ORNL Evaluation of Electrabel Safety Cases for Doel 3 / Tihange 2: Final Report (R2)

November 2015

**ORNL EVALUATION OF ELECTRABEL SAFETY CASES
FOR DOEL 3 / TIHANGE 2: FINAL REPORT (R2)**

Fig. 5.5 Application of EBL flaw screening criterion to D3/T2 (a) Doel 3 and (b) Tihange 2 (Figs 3.5.9 and 3.5.10 in ref.[1]).

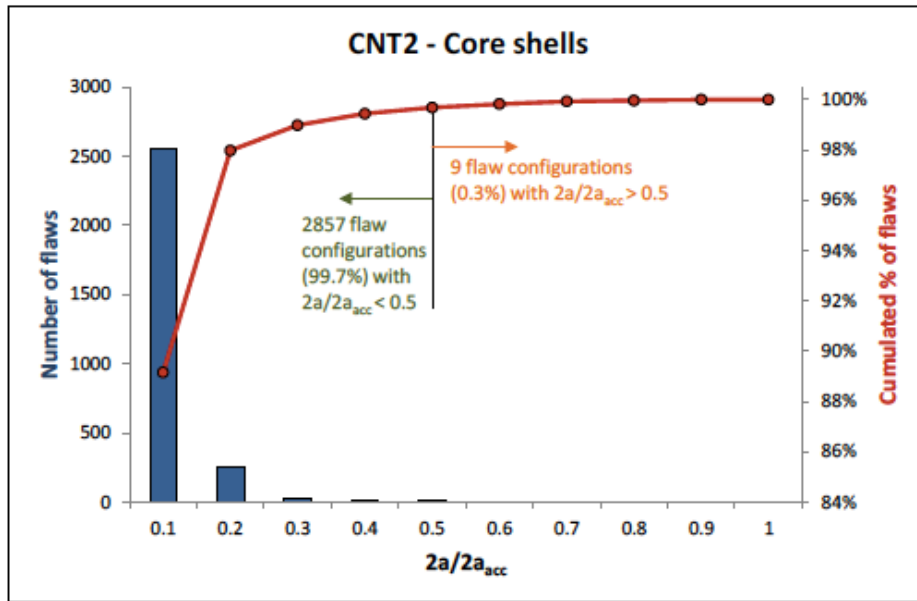
Results from ORNL screening assessments of D3/T2, given in Fig. 5.9-Fig. 5.14 and Table 5.2, are compared herein to the EBL assessments. Histograms of the EBL screening results are shown in Fig. 5.5, indicating a total of 28 non-compliant characterized flaws for Doel 3 and nine for Tihange 2; the EBL screening assessments are based solely on ASME Section XI (1992 – Criterion *I*). Table 5.3 compares the total number of EBL-characterized flaws found not compliant with ASME acceptance criteria in the EBL and ORNL analyses; totals are broken down for each plant and, in the case of ORNL analyses, according to ASME 1992 and 2004 acceptance criteria.

Fig. 5.9 ASME(1992) Criterion I: ORNL Flaw Acceptance Analysis – Doel 3 Lower Shell (see Section 5.6.5 for details regarding this figure).

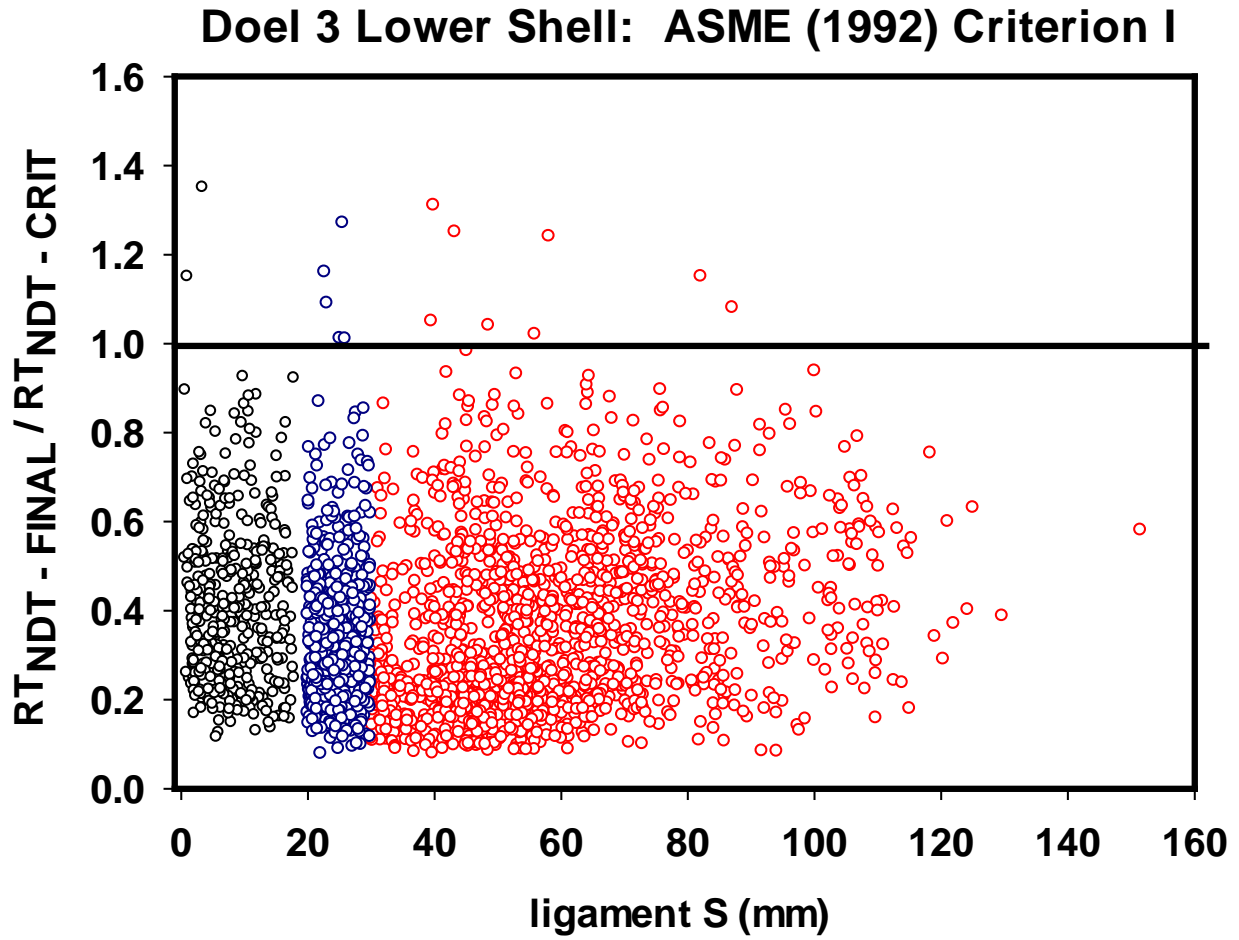
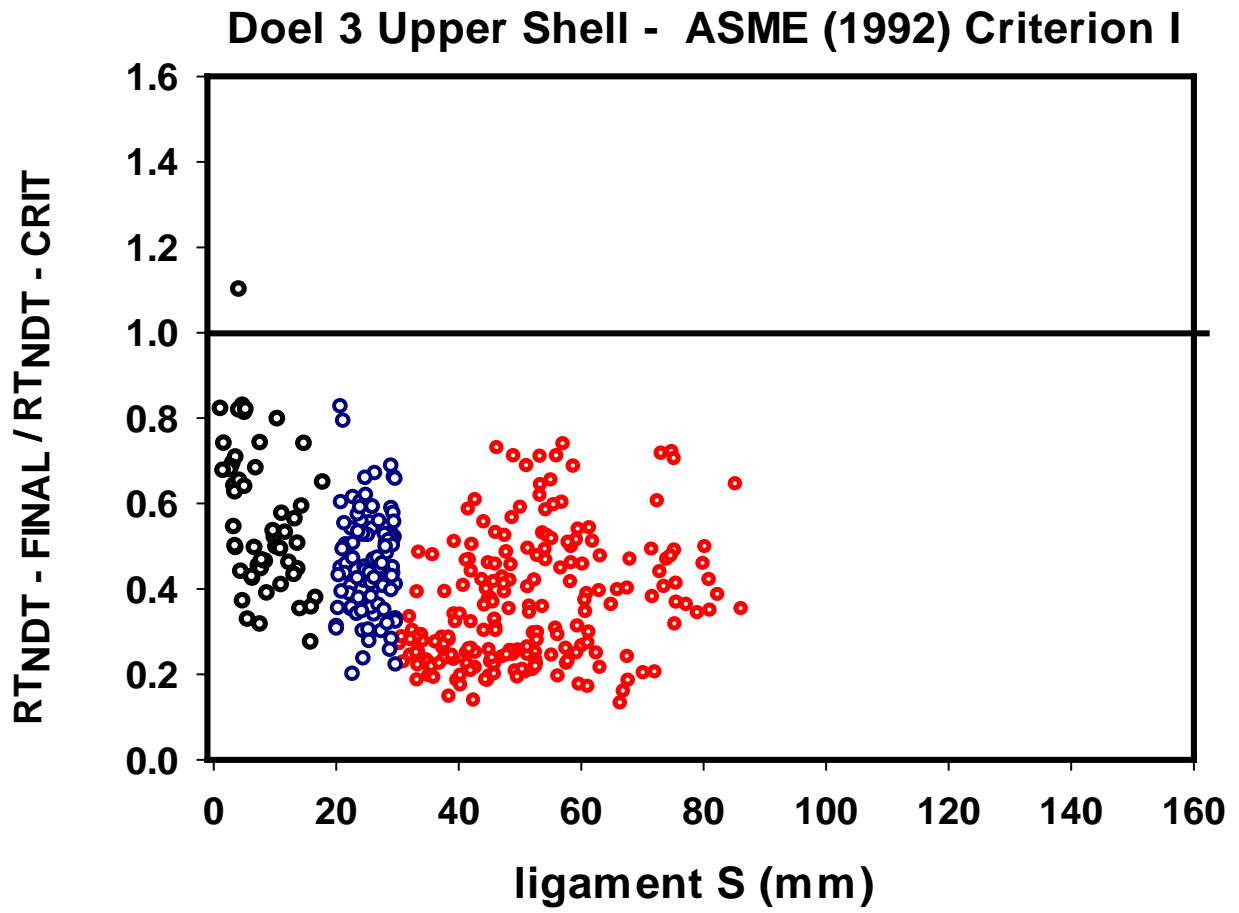
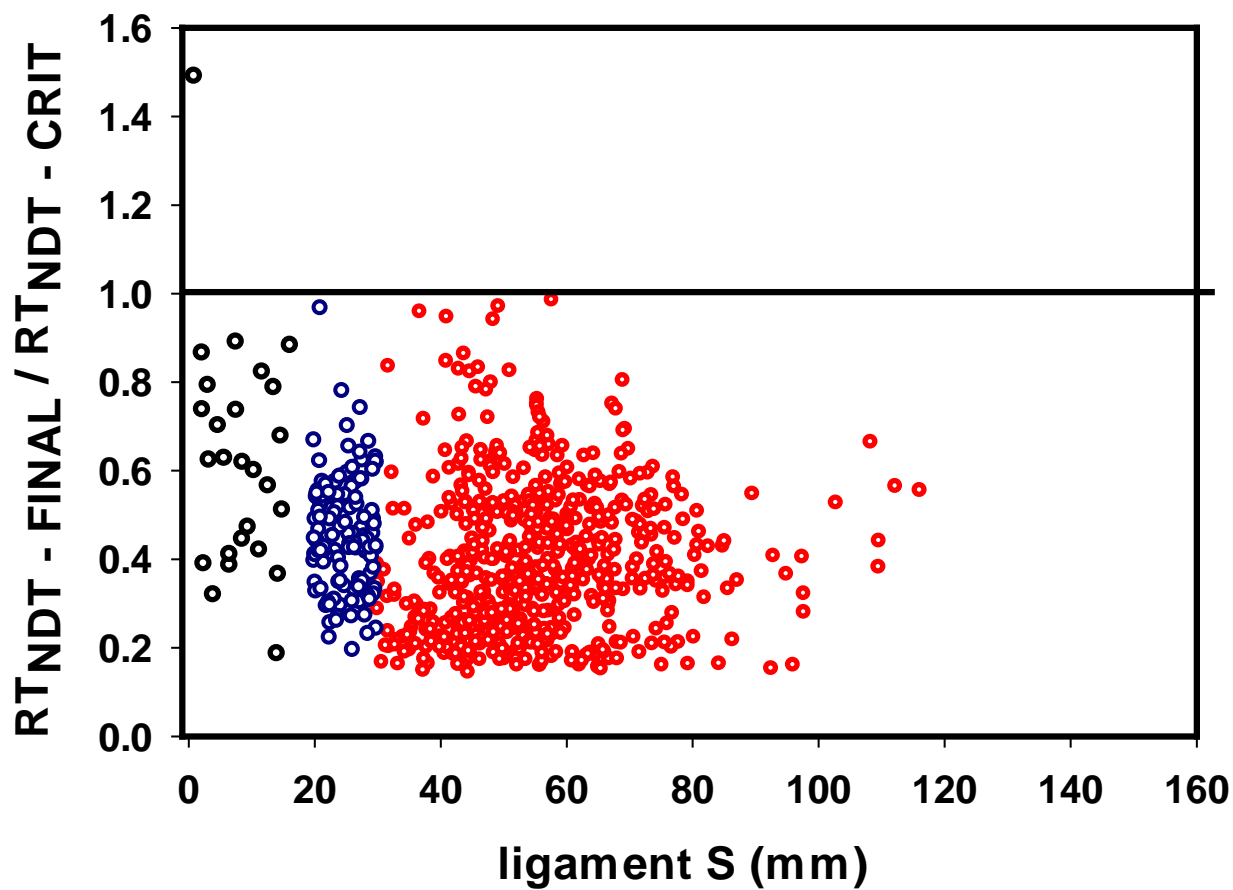
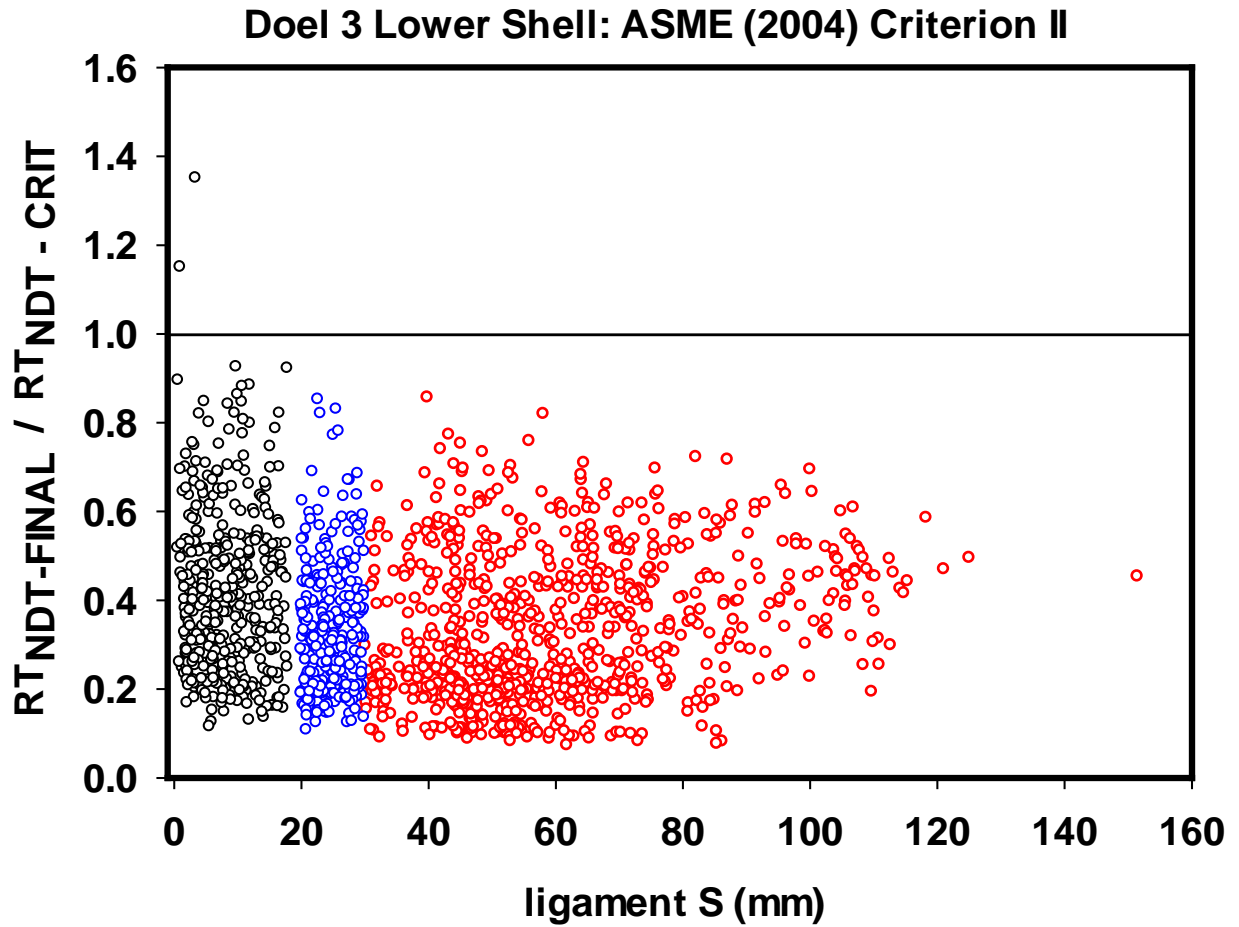
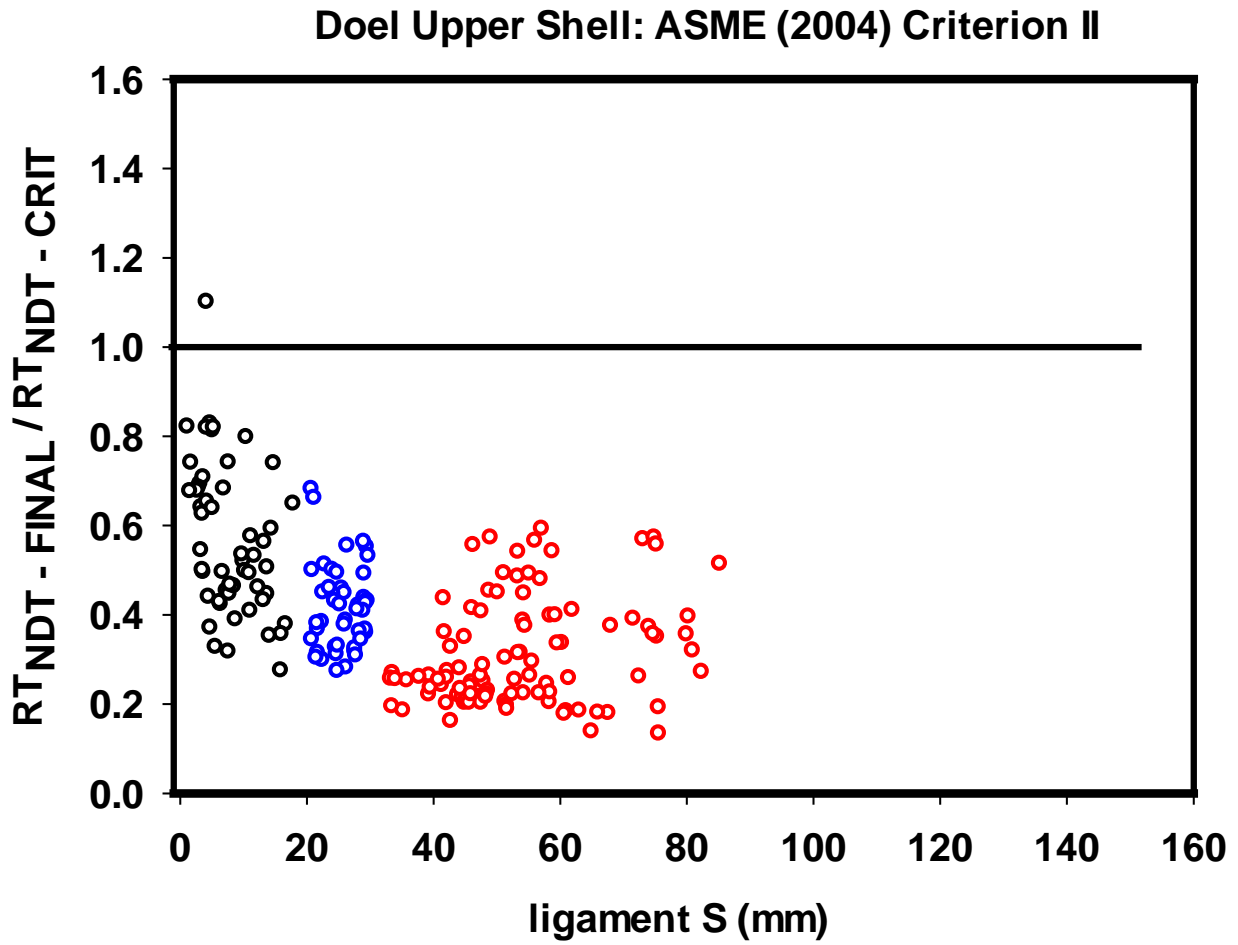
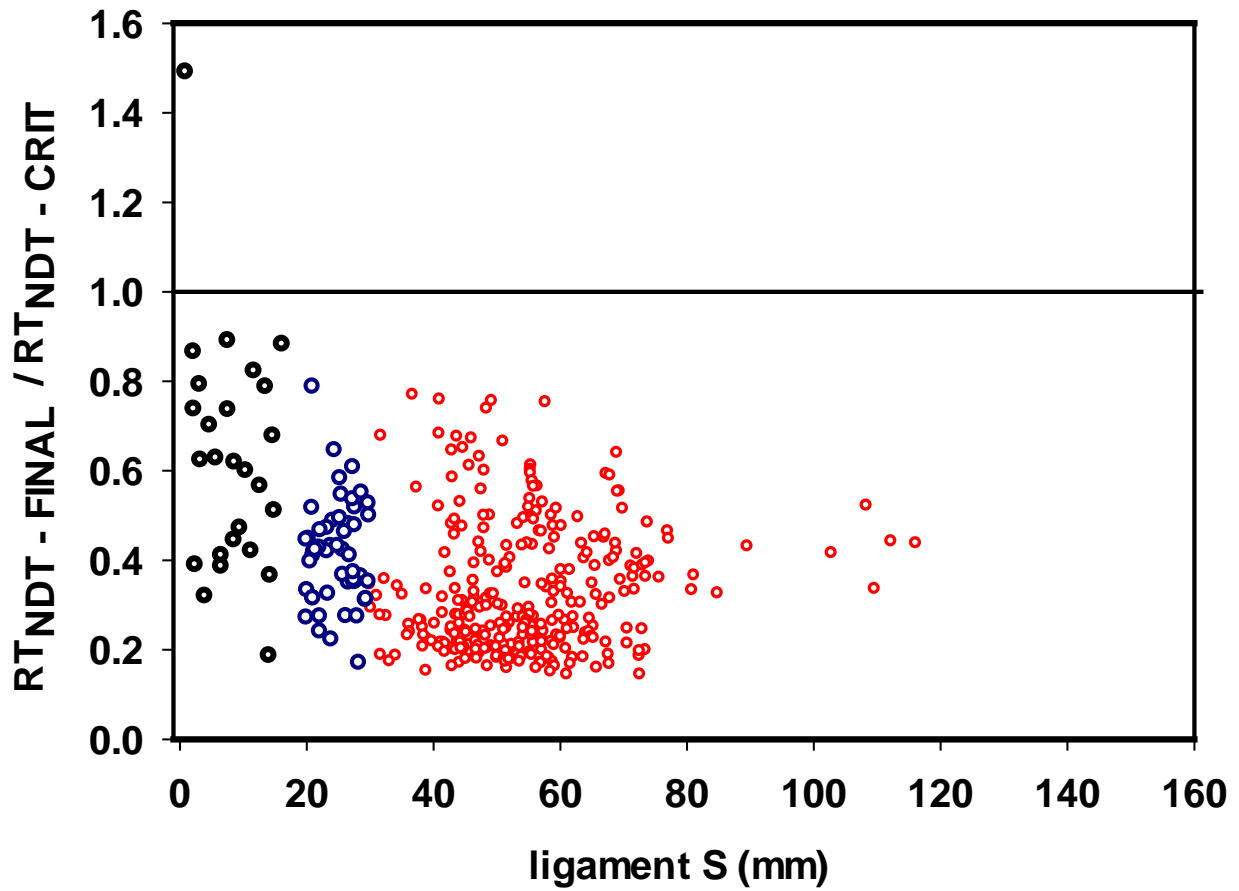
In Table 5.2 (a), application of ASME (1992 – Criterion I) produced 17 non-compliant flaws for the two plants, where

In Table 5.2 (b), the less restrictive acceptance criterion for level A/B loading defined in ASME (2004 – Criterion II) resulted in all flaws being acceptable for cool-down and heat-up transients; results for LOCAs were the same as for ASME (1992 – Criterion I), as the acceptance criterion is unchanged.

Fig. 5.16 Comparison of response of axial and circumferential planar flaws and quasi-laminar (Q-L) flaw 1660 to the applied transient. Overlay of the critical K_{Ic} curve indicates that the Q-L flaw is not predicted to initiate in cleavage fracture.

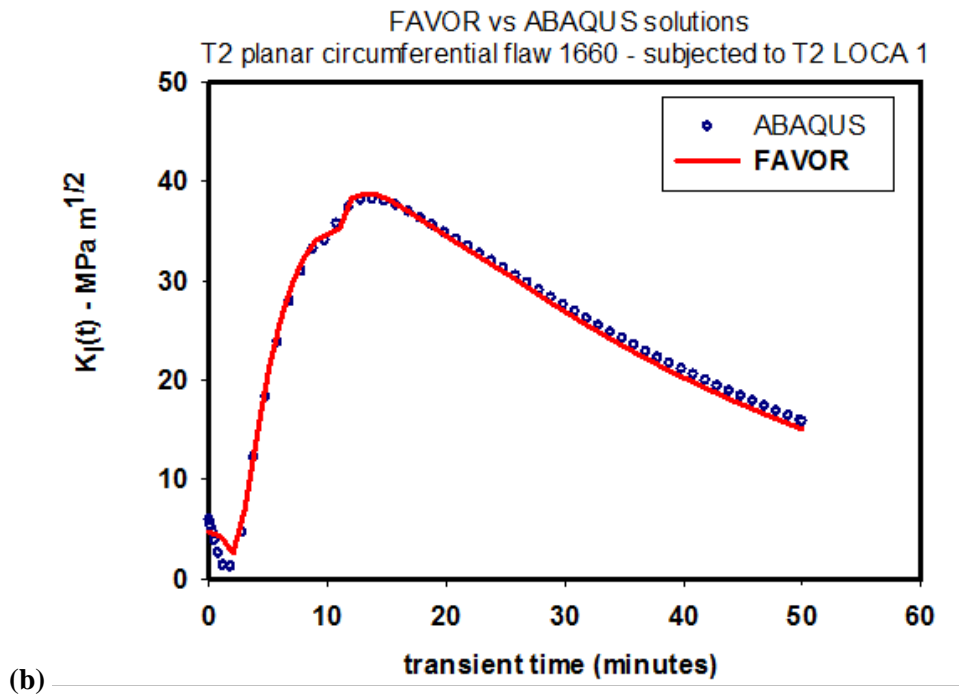
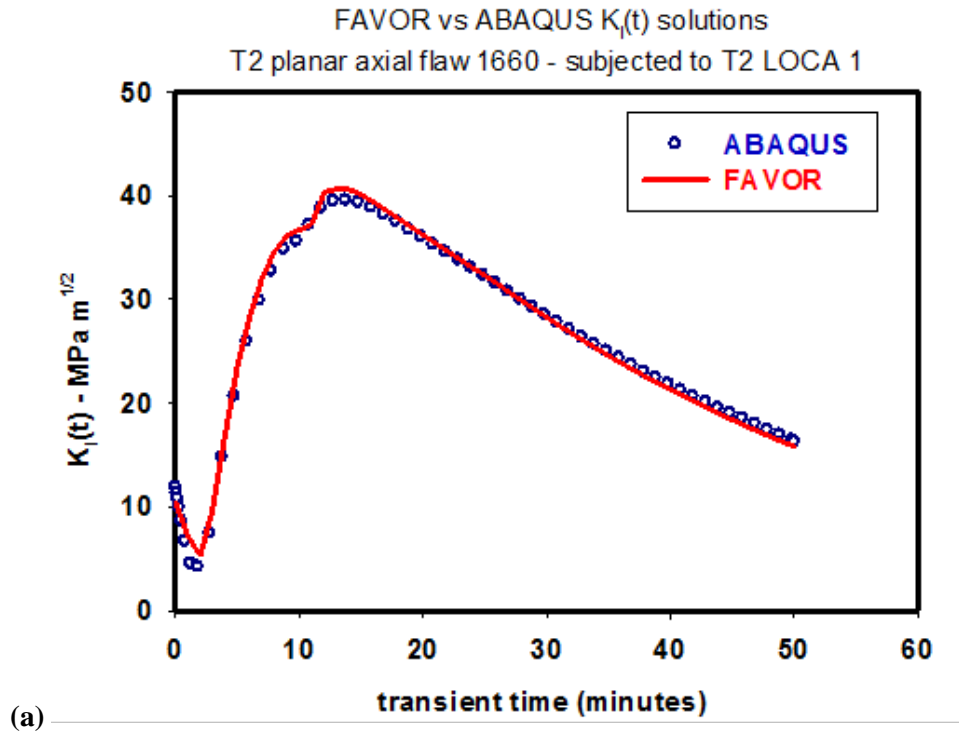
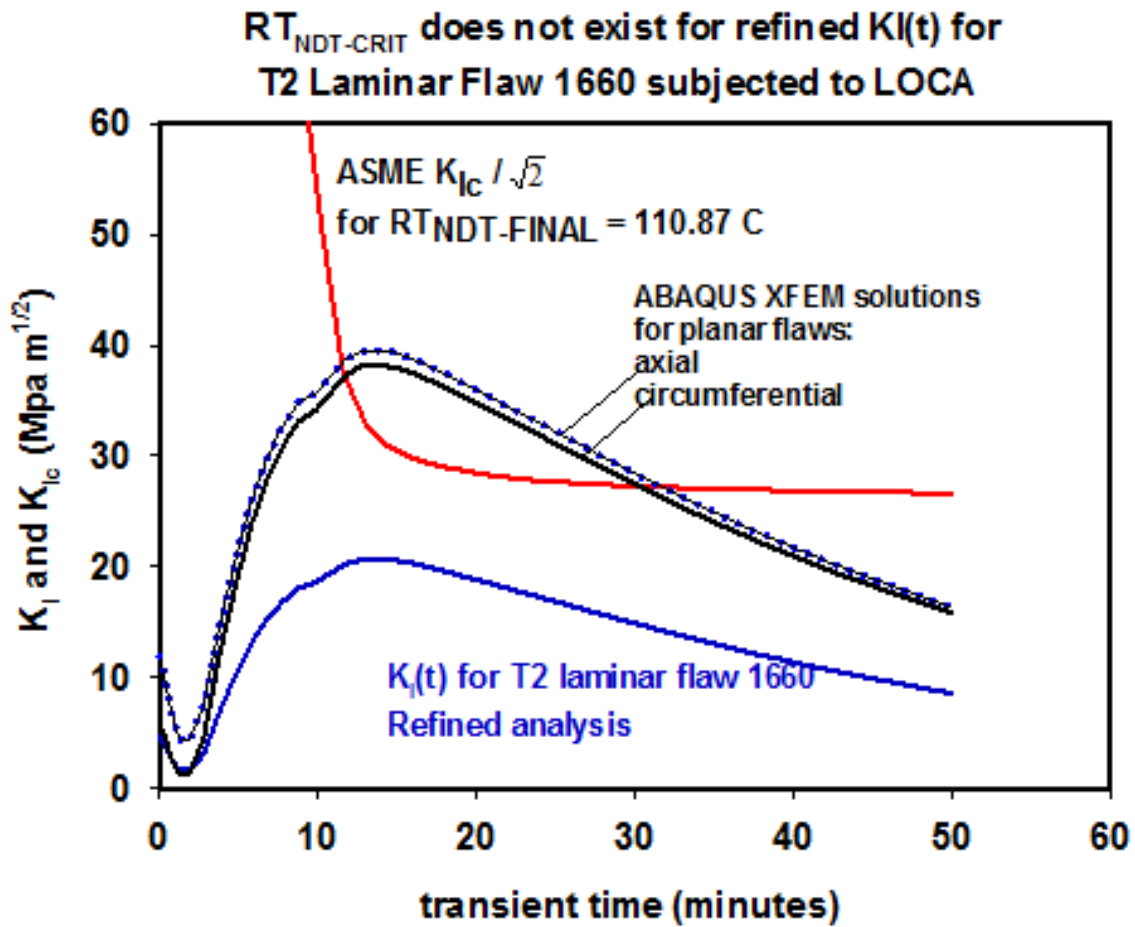
Figures 5.15 (a) and (b) present the results of an initial benchmarking exercise carried out by ORNL to determine if the XFEM methodology, as implemented in the ABAQUS commercial finite element code (v 6.14-1) ref. [26], could reproduce the applied K_I vs time histories calculated by the FAVOR, v12.1, code for the transient under study. In Figs. 5.15 (a) and (b), flaw 1660 is postulated to be a planar flaw in the axial and circumferential orientations, respectively. The good agreement shown in Figs. 5.15 (a) and (b) provided the necessary confidence to then pursue a refined XFEM analysis of the observed quasi-laminar (Q-L) orientation for flaw 1660.

The results of the ORNL Q-L flaw analysis are summarized in Fig. 5.16 (see Appendix D in this report for full details). By comparing the Q-L flaw 1660 applied K_I history (calculated by the ORNL XFEM analysis) to the ASME K_{Ic} curve (with safety factor of $\sqrt{2}$), it is clear that, by this analysis for the Q-L orientation, flaw 1660 will not initiate in cleavage fracture.

Fig. C.1 Assessment of flaw group GP0818 found in the Doel 3 lower shell and subjected to the postulated LOCA; flaw group passes ASME acceptance criteria if WPS included in the analysis.

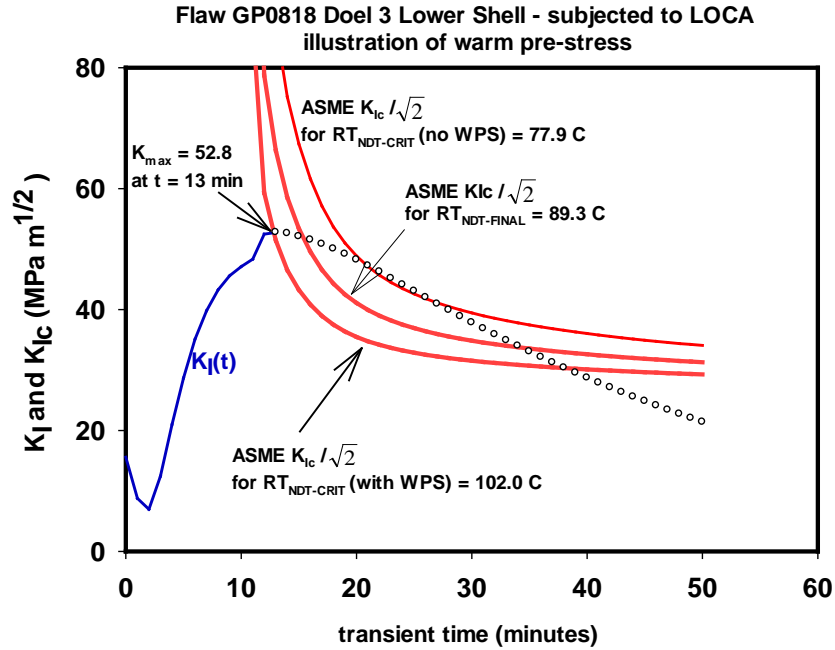
Figure C.1 depicts an assessment of flaw group GP0818 found in the Doel 3 lower shell and subjected to the postulated LOCA (see Appendix B); assessment results are shown with and without inclusion of WPS. Without WPS, a value of $RT_{NDT-CRIT} = 77.9$ °C provides a point of tangency between applied $K_I(t)$ and the fracture toughness curve. That point of tangency occurs after the maximum value, $K_{I,max}$, has occurred and, thus, does not satisfy the WPS criteria. Inclusion of WPS increases the critical value to $RT_{NDT-CRIT} = 102$ °C. Thus,
